GRBP 70th session
Document GRBP-70-19
Agenda items 6 and 14

NEW TRACTION DEFINITION

NEW DEFINITION

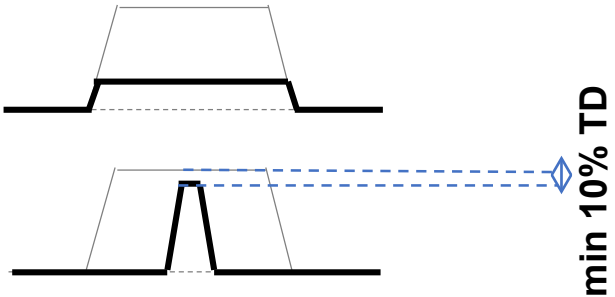
*Elements separated
by grooves/sipes having
their depth **in average**
min 70% of tread depth AND
everywhere **min 10%** of tread depth*

**Stronger requirements concerning the separating grooves/sipes
from 50% to 70% and never below 10%**

NEW LIMIT PROPOSALS

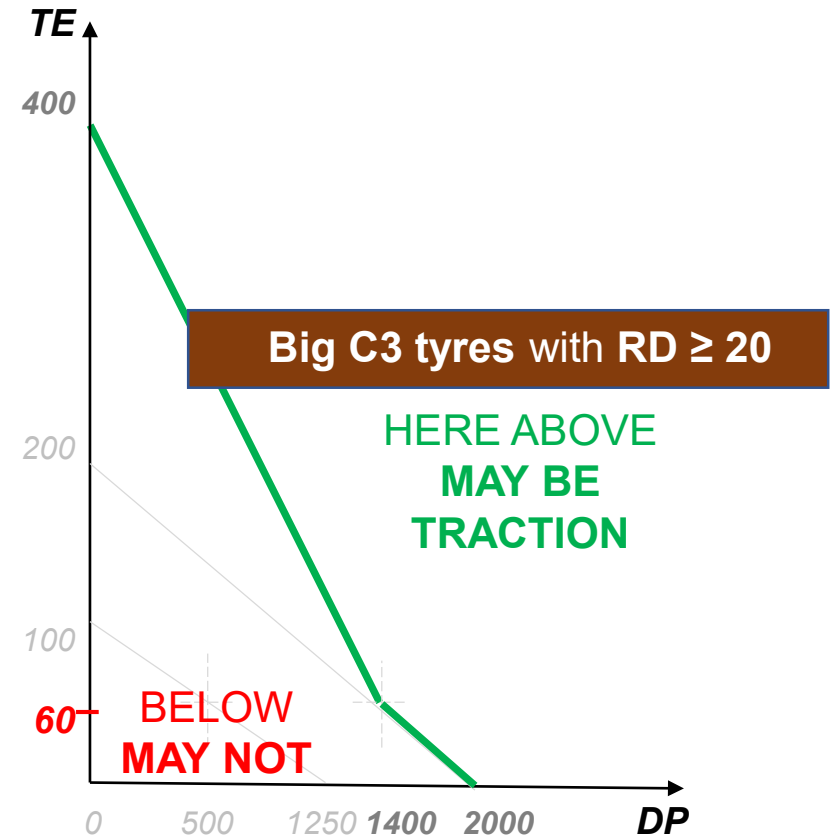
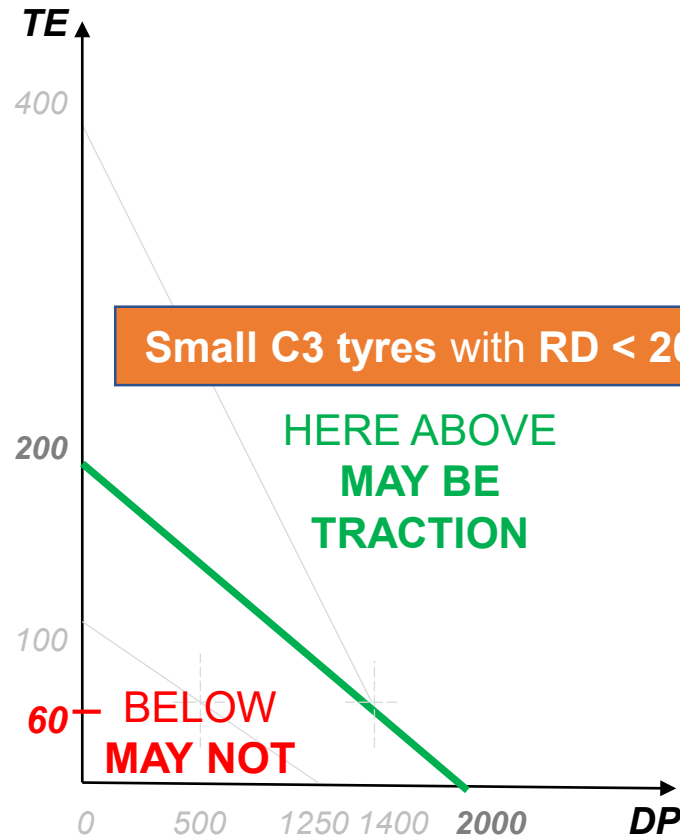
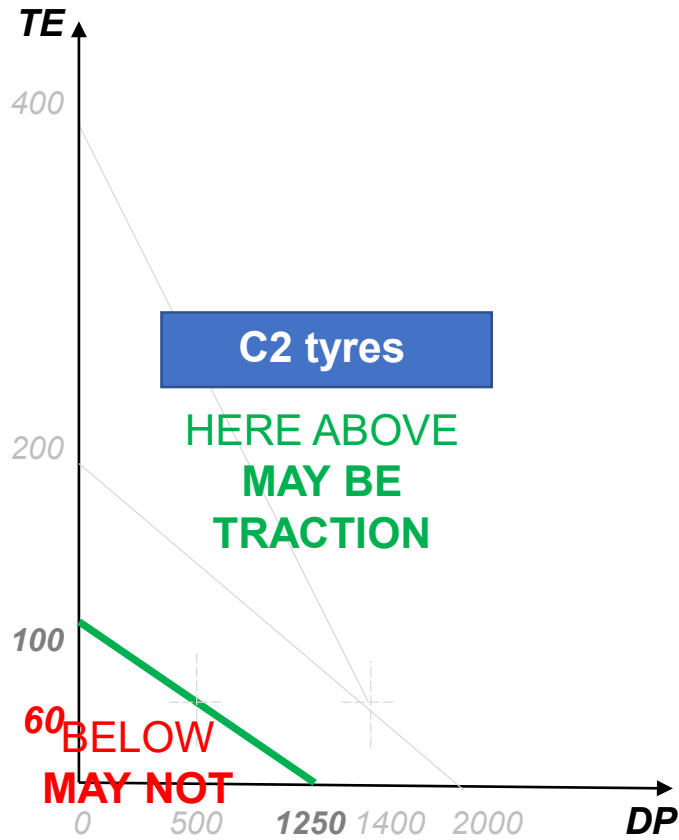
NEW TRACTION LIMITS
C2 - SMALL C3 - BIG C3

TE : Total amount of Elements in tread pattern
DP : Pattern Deformation Potential = $VR \cdot TD^3$
RD : Nominal Rim Diameter code
